XPROG-m Errata Sheet 001

This errata provides information applicable to the following products:

- 1-002-0017 programming adapter Rev.B or earlier

STEP1

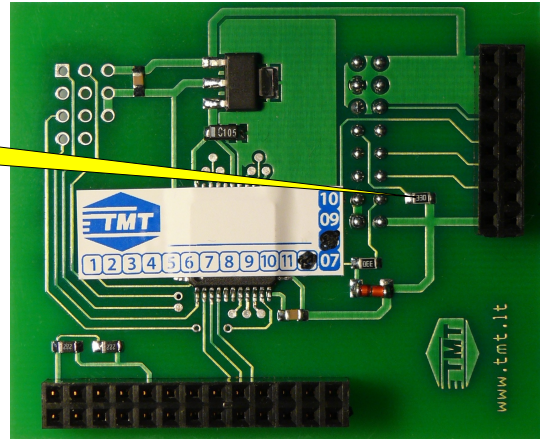
Remove this resistor

STEP2

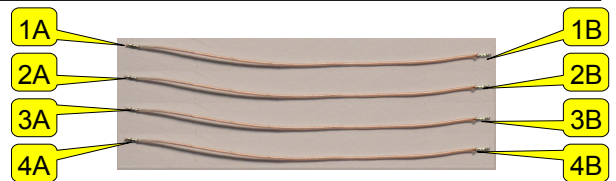
- Prepare the four wires. About 5cm in length.

STEP3

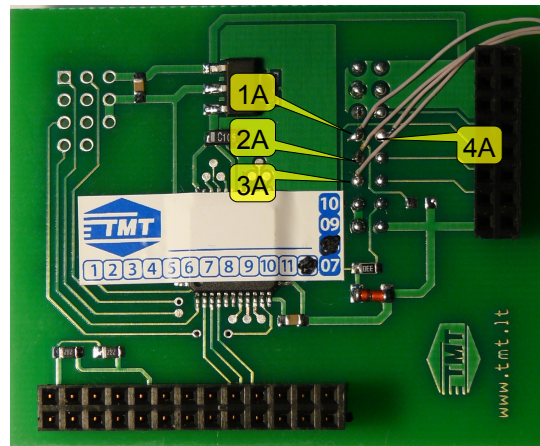
- Solder wire shown in the corresponding points at the bottom side
